Green hat outline is for Standard 56x65mm Pi4 hat design and is what we are currently using for the mainboard.

RED hat outline of 74x74mm is the maximum design size that we can use without redesigning the case.  
NOTE the directions that the board can expand

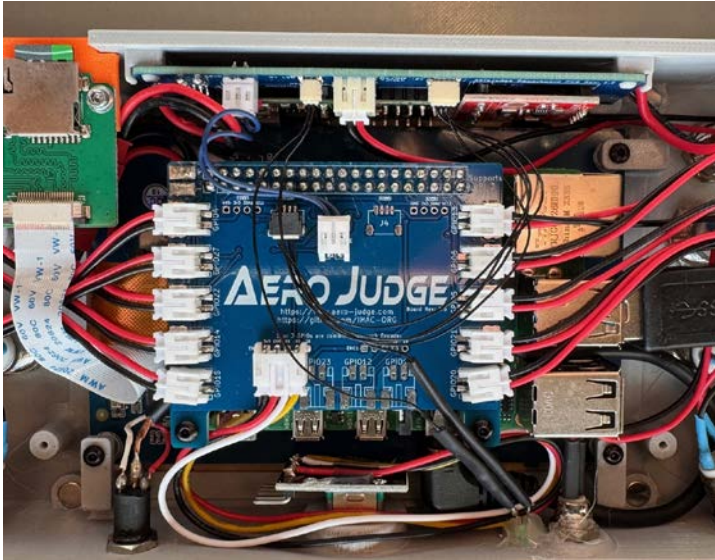
Can use full RED outline.  
JST Ph2 connectors can be through hole type for tighter spacing. Prefer to keep these in order on the sides if possible.
